Re: On-Going Services  
Riverwood Ranch Section 3 Final Plat and Construction Plans – 1<sup>st</sup> Submittal Review  
Angleton, Texas  
HDR Job No. 10361761

HDR Engineering, Inc. (HDR) has reviewed the construction plans and final plat for the above referenced subdivision and offers the following comments:

PLAN & PROFILE  
 ROBIN STREET  
 STA. -1+60 TO 4+20  
 PROJECT NO. 14396

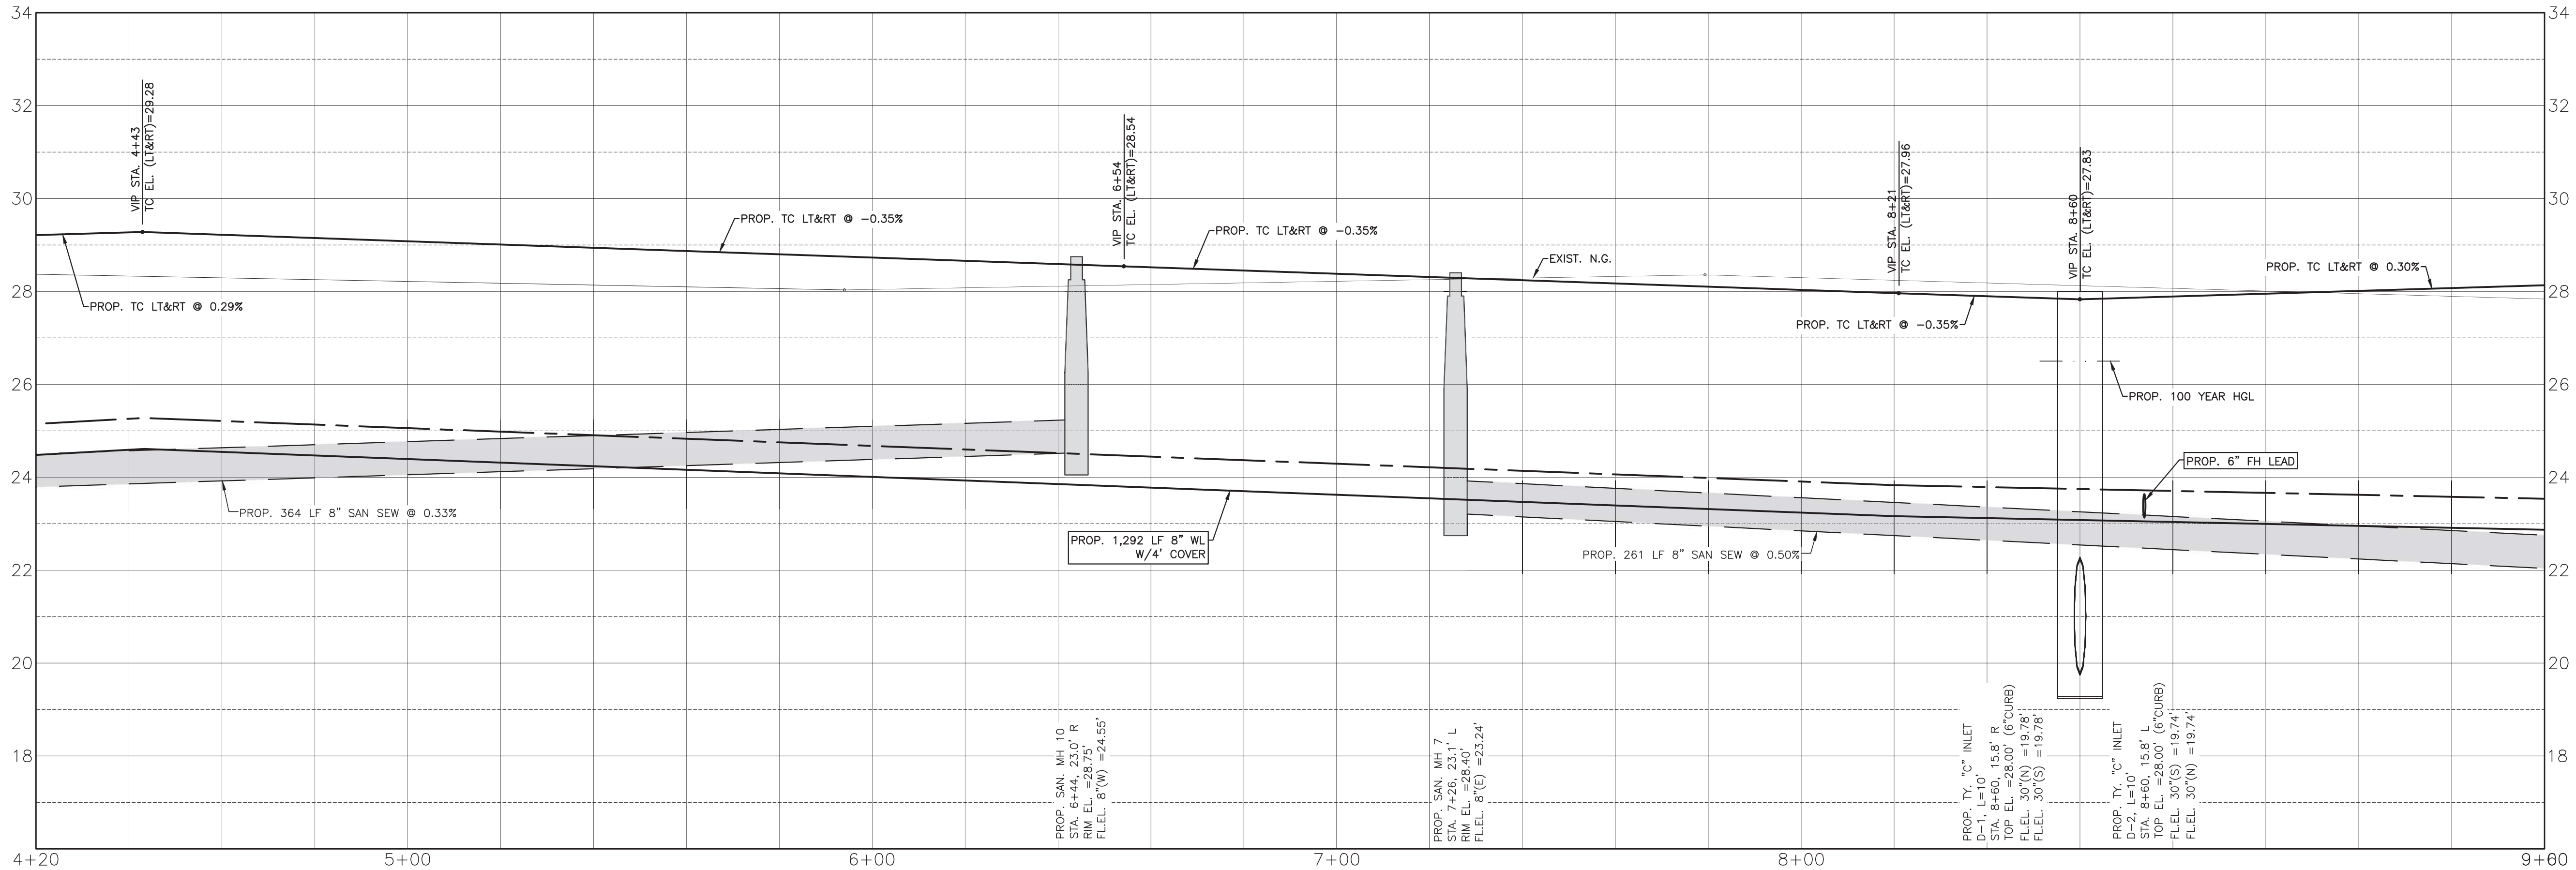
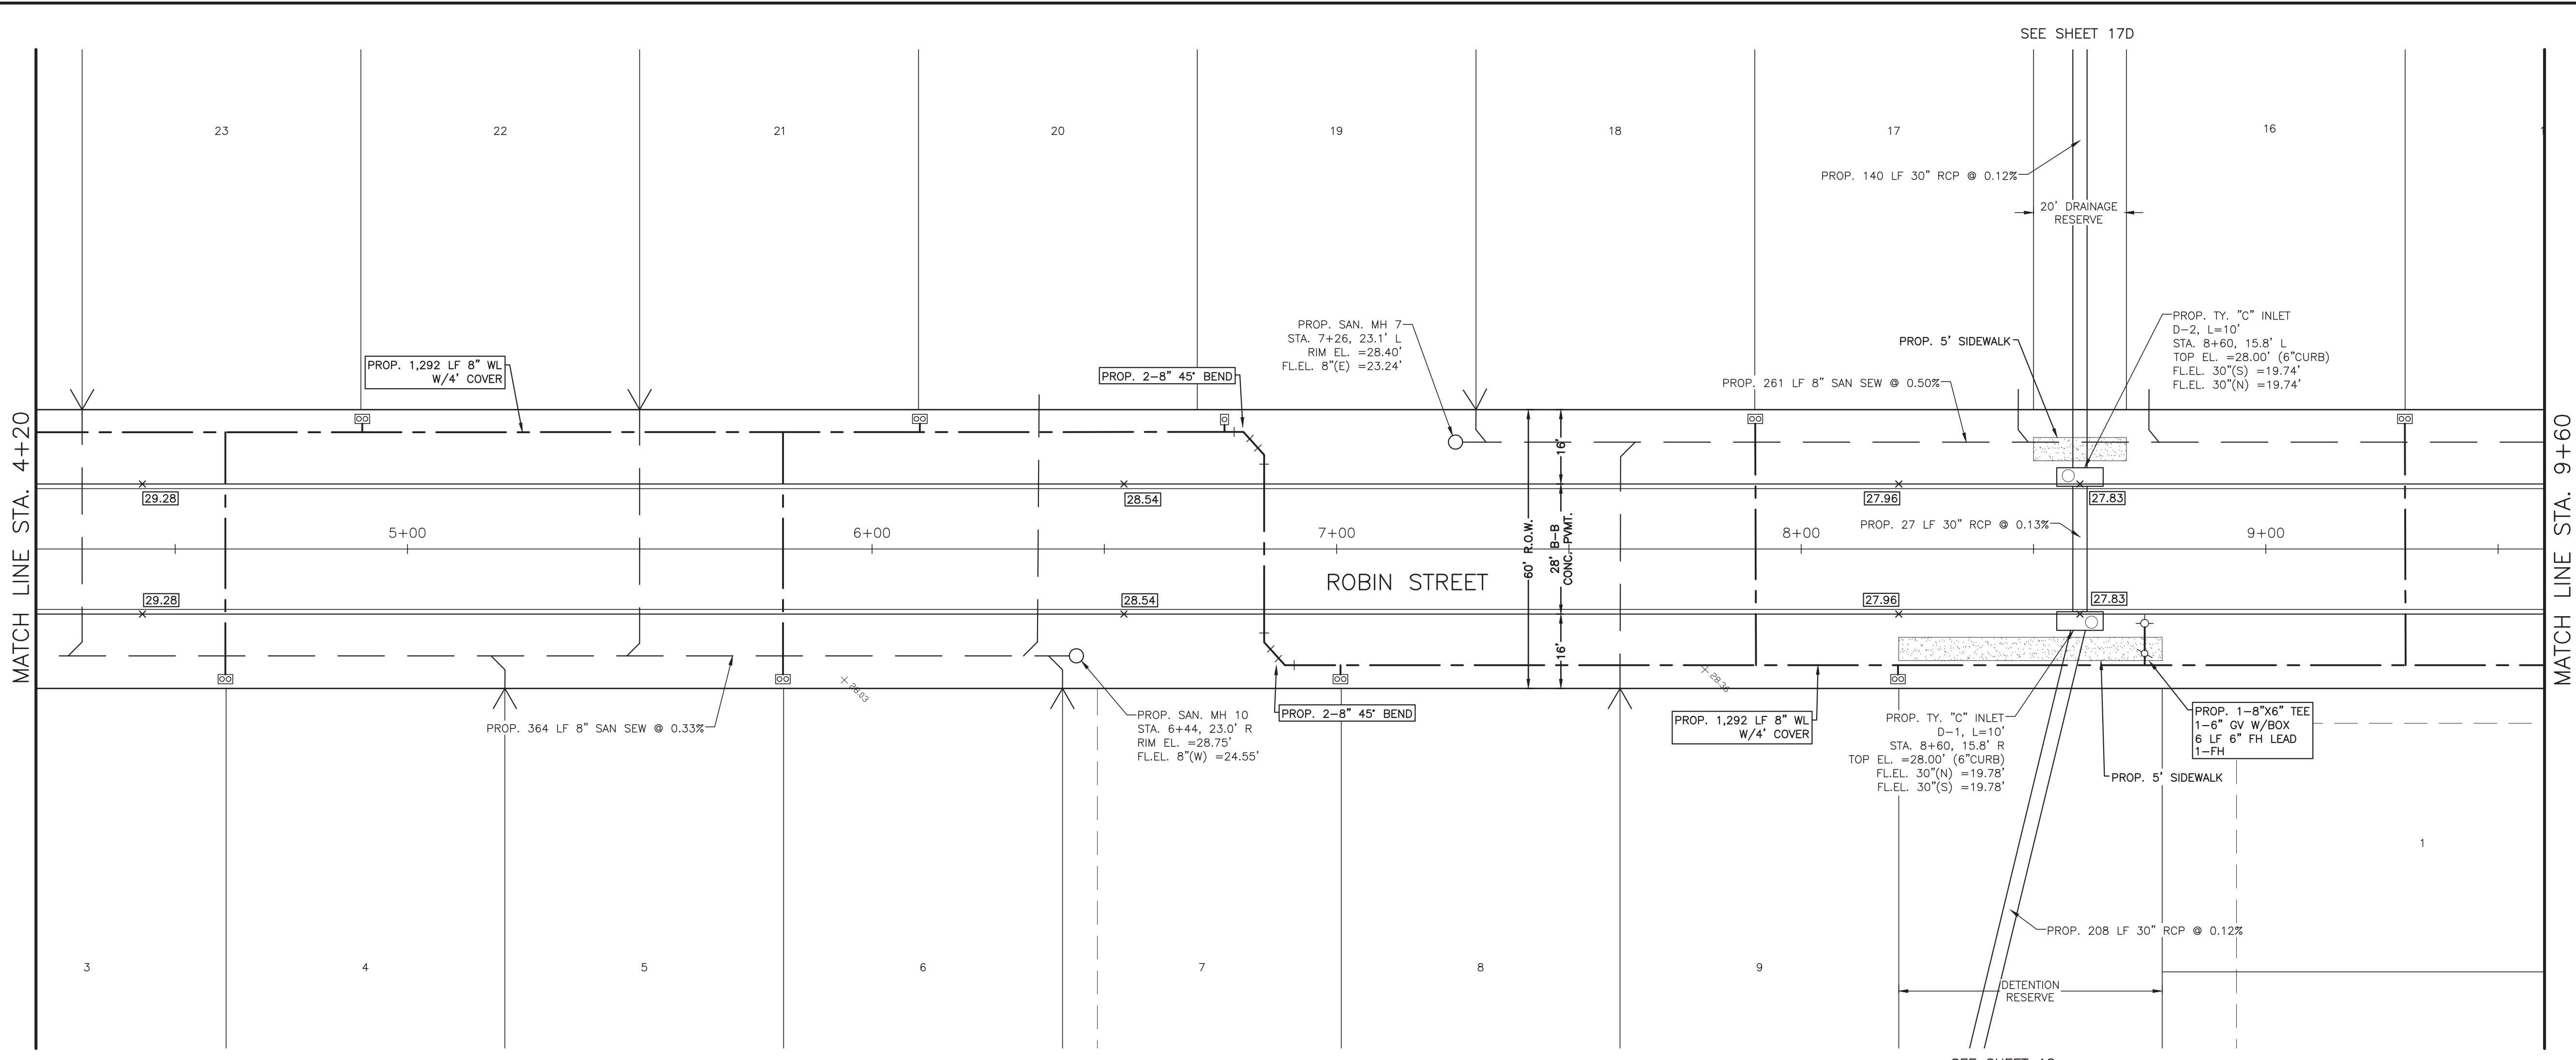
1. Proposed water line is in conflict with proposed sanitary sewer near Sta. 3+15.

PLAN & PROFILE  
 AMY STREET  
 STA. 0+00 TO 3+20  
 PROJECT NO. 14396

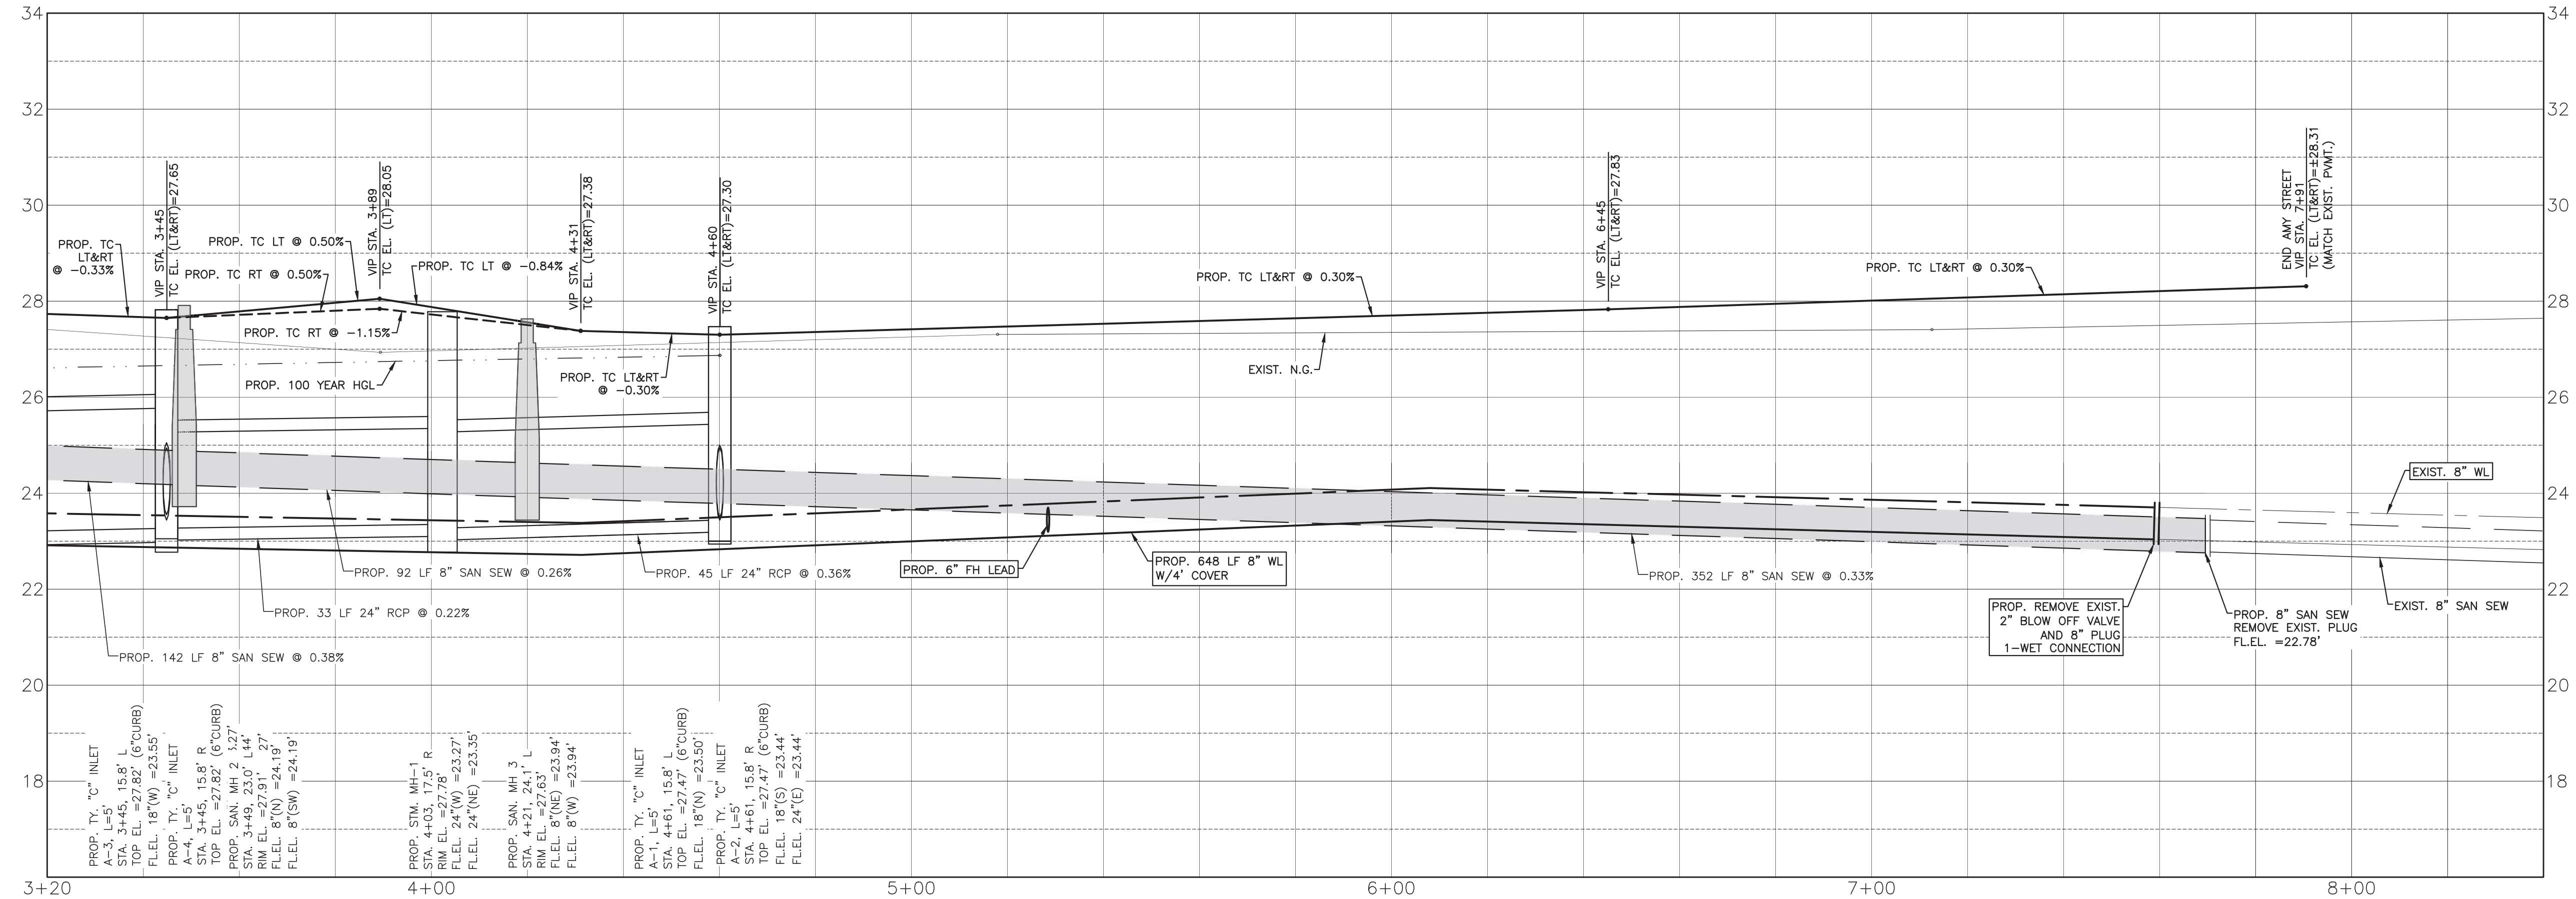
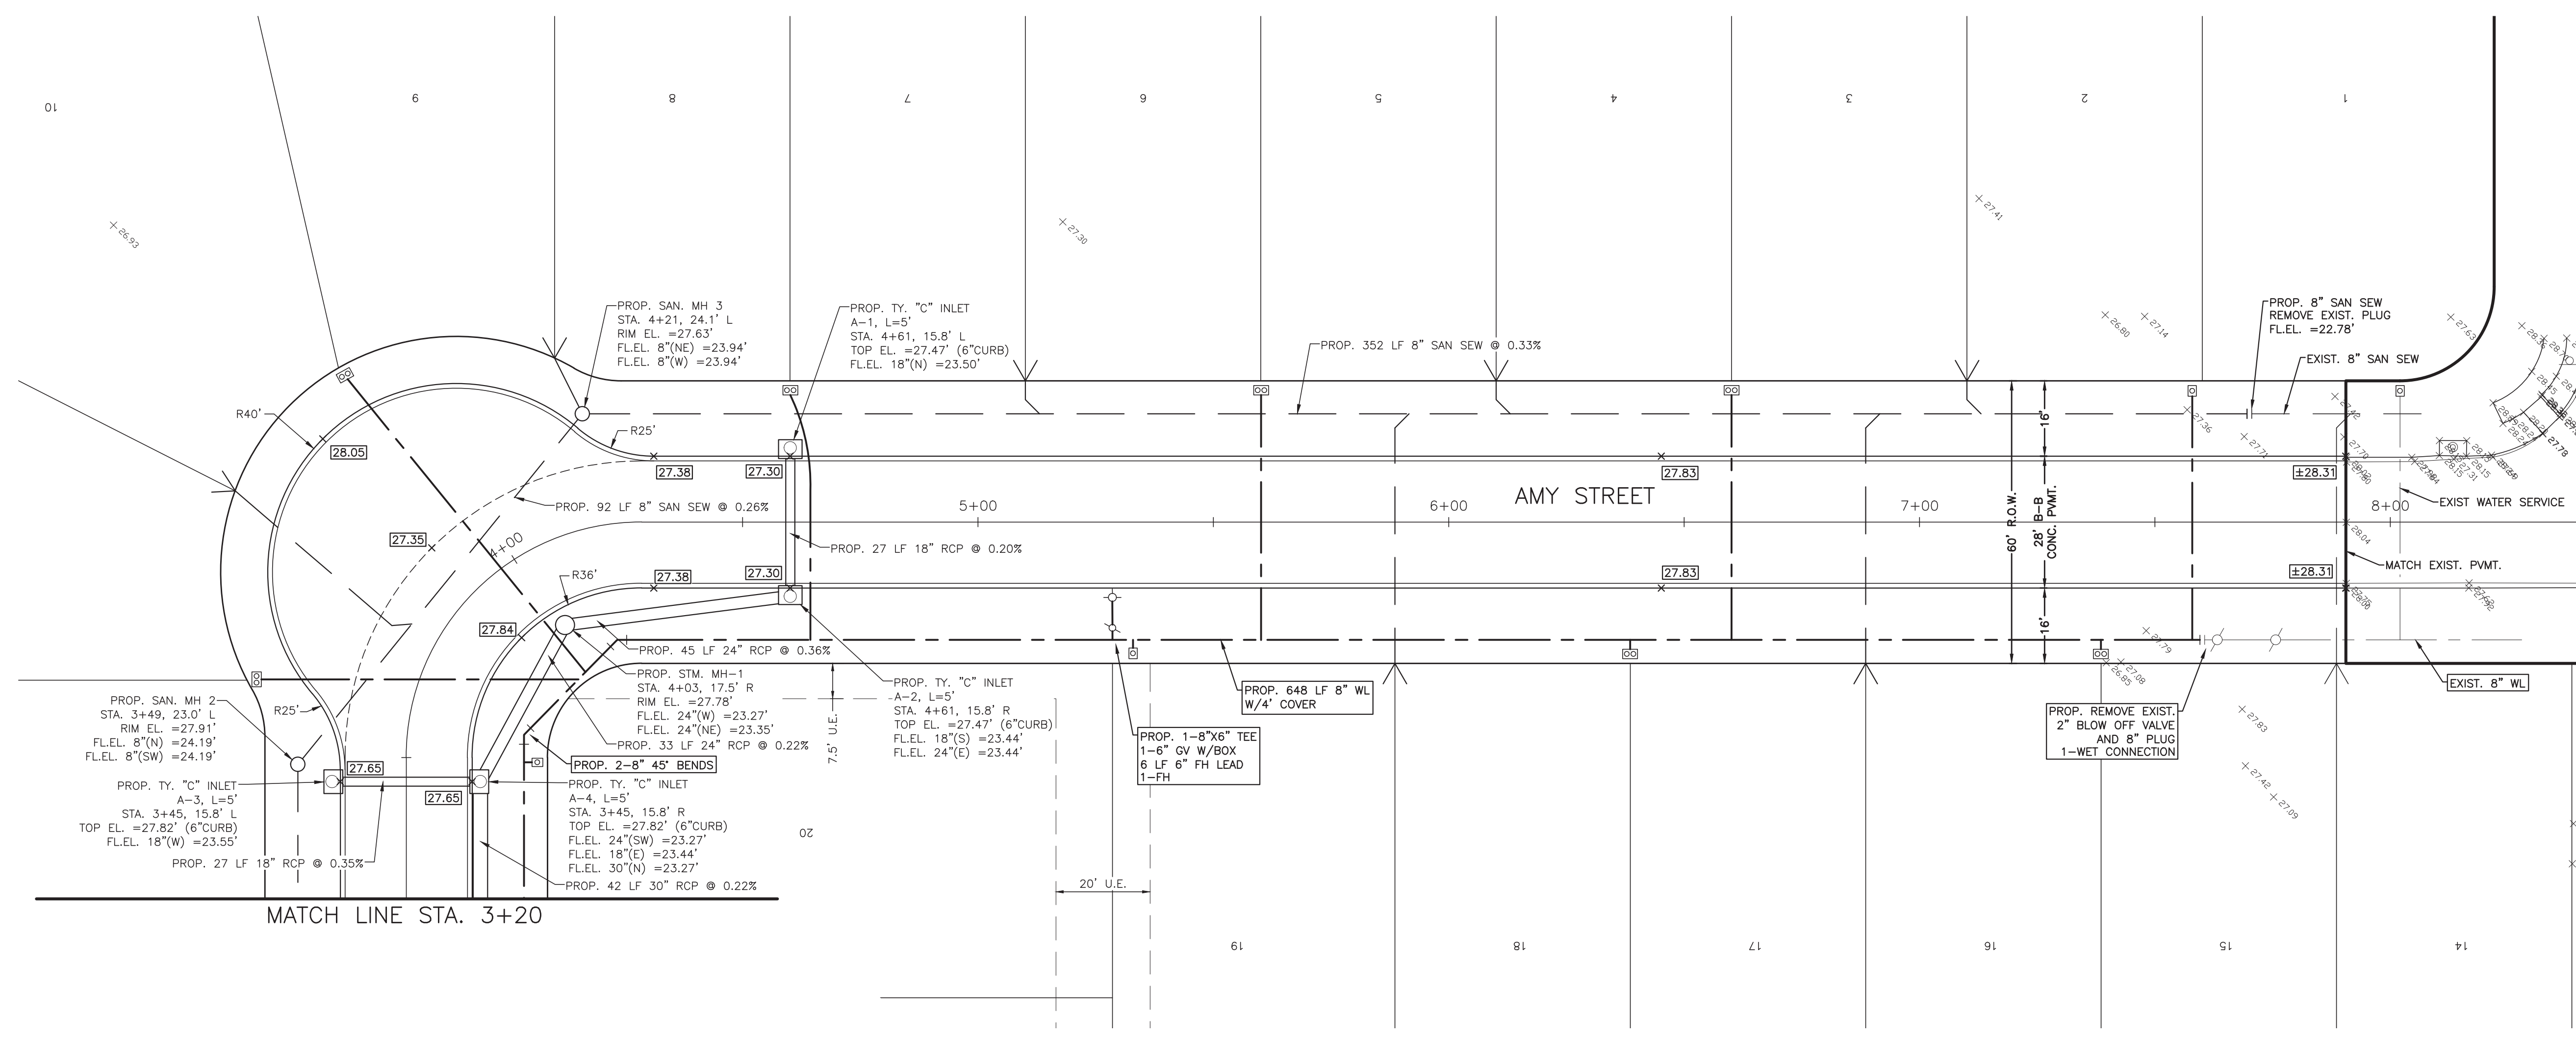
1. Verify and update water surface elevations shown for 25yr and 100yr.

Verify and update water surface elevations shown for 25yr and 100yr
